BRIDGE NO. 1

SOUTHERN CONCRETE CONSTRUCTION CO., INC.	P. O. BOX 50157 ALBANY, GA 31703-0157 TEL: (229) 435-0786 FAX: (229) 434-4755		
BENT 2 AS BUILT SR 73 (US 301) OVER OGEECHEE RIVER OVERFLOW SCREVEN COUNTY BHN00-0068-02(023)			
JOB NO. 201316	MARCH 2014		
SHEET 1 OF 1	DESIGNED HNTB / BHB DRAWN BHB	SCALE NO SCALE CHECKED BHB

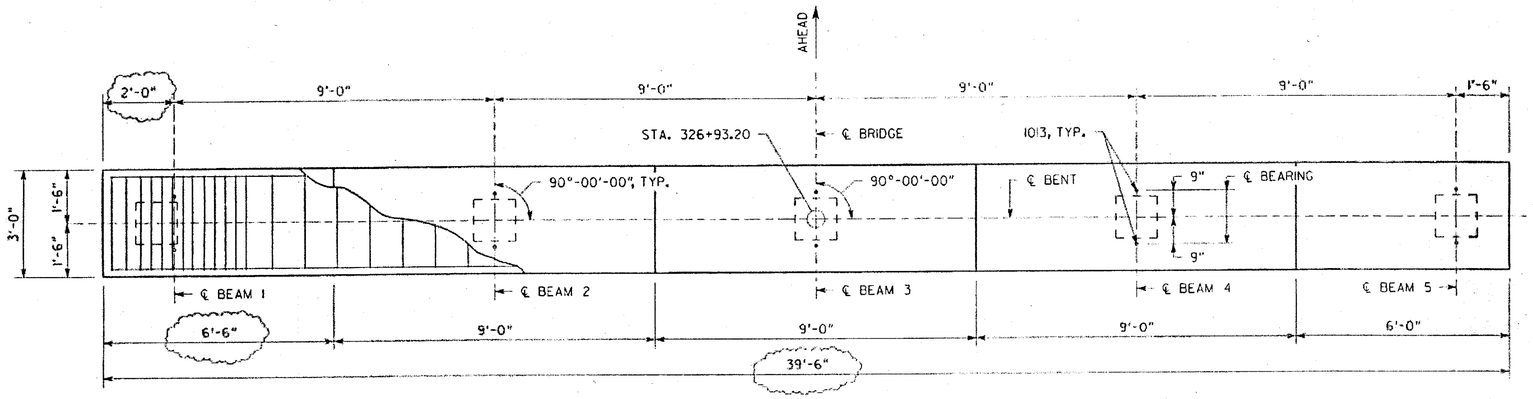
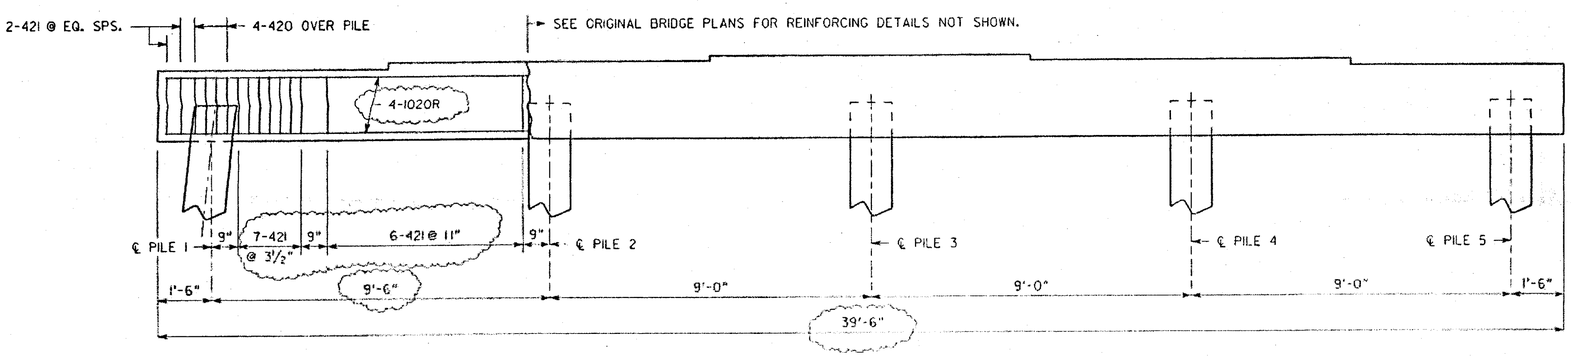
1. CAP LENGTHENED 6" TO ACCOMODATE PILE 1.
2. PILE 1 IS DRIVEN AT A BATTER OF APPROXIMATELY 12 (V) TO 1.25 (H).
3. PILE 5 IS BE DRIVEN VERTICALLY TO AVOID THE ABANDONNED PILE ORIGINALLY DRIVEN. SCC WILL DRILL A PILOT HOLE FOR THE VERTICAL PILE TO ENSURE THAT THERE IS NO CONFLICT.
4. ADDITIONAL 421 BARS HAVE BEEN ADDED BETWEEN PILES 1 AND 2. REVISE QUANTITY FROM 40 TO 44.
5. 1020 BARS HAVE BEEN REVISED TO 1020R AND LENGTHEND TO ACCOMODATE THE EXTRA CAP LENGTH. 1020R BAR LENGTH = 39'-2".

Approved in general. Details not checked. This approval shall not relieve the Contractor of any responsibility for conformity with the contract Plans and Specifications.
